ASME Record #19-2867 – Revision ASME STS-1-2016 – Ladder Requirements

Underlined additions, Strikethrough deletions

FIGURE 6.3.7-(a-e) LENGTH OF CLIMB

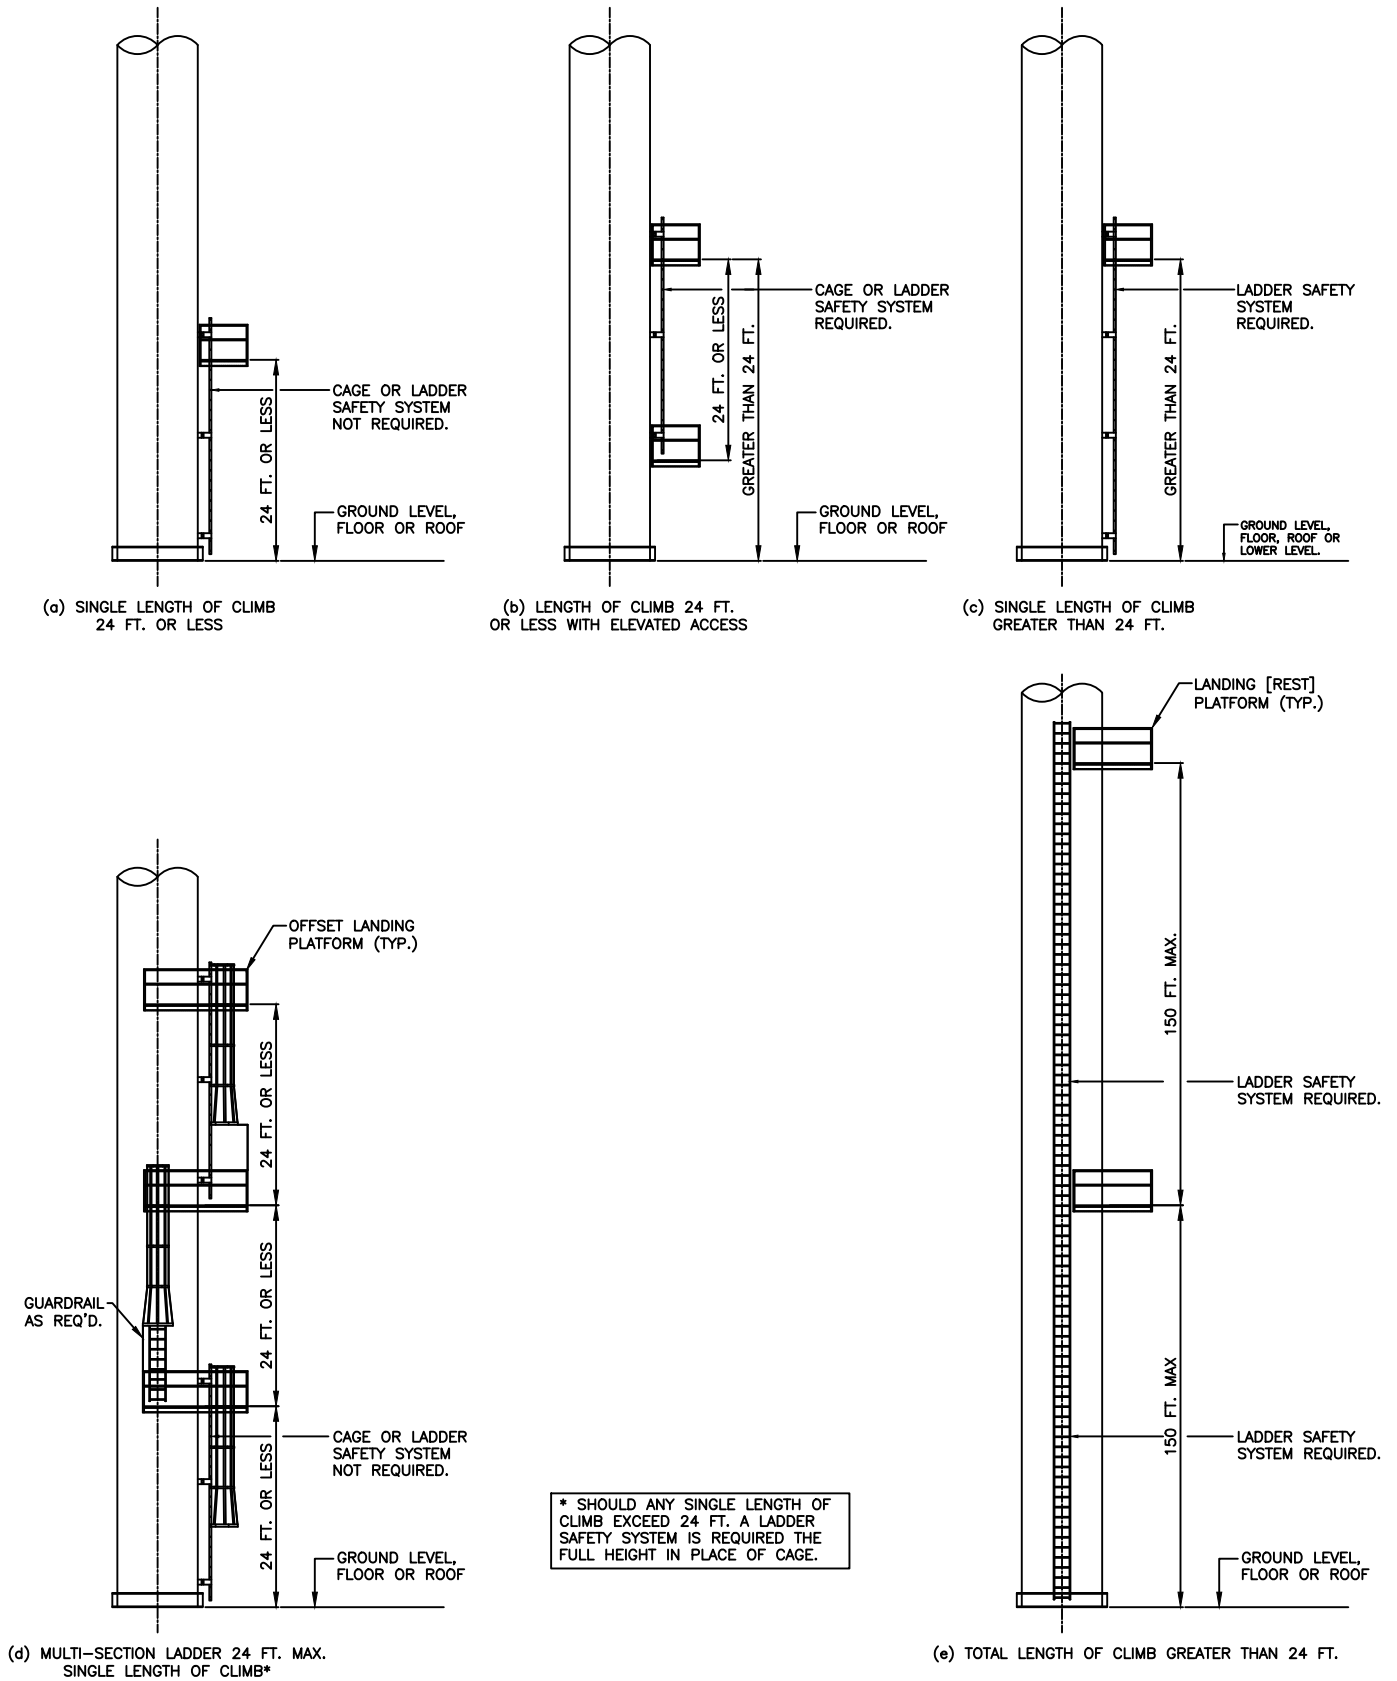
A description of the permissible length of climb is provided below for the different ladder configurations presented in Figure 6.3.7-1.

(a) A cage or ladder safety system is not required where the length of climb is 24 ft or less above a ground level, floor or roof. See Figure 6.3.7-1, illustration (a).

(b) A cage or ladder safety system shall be provided where the length of climb is less than 24 ft, but the top of the ladder is at a distance greater than 24 ft above a ground level, floor or roof. See Figure 6.3.7-1, illustration (b).

(c) A ladder safety system shall be provided where a single length of climb is greater than 24 ft. See Figure 6.3.7-1, illustration (c).

(d) Multiple sections of ladders having all single length of climbs not exceeding 24 ft shall be provided with a cage or ladder safety system. See Figure 6.3.7-1, illustration (d). Refer to Par. 6.3.8-3 and 6.3.11-8 for landing requirements when caged ladders are used.

(e) Multiple sections of ladders having at least one single length of climb exceeding 24 ft shall be provided with a ladder safety system in place of a cage. The ladder safety system shall be provided throughout the length of climb. See Figure 6.3.7-1, illustration (d).

(f) Ladders equipped with a ladder safety system shall have rest platforms at maximum intervals of 150 ft. See Figure 6.3.7-1, illustration (e).

(g) When a ladder safety system is combined with a cage the maximum single length of climb shall not exceed 50 ft.
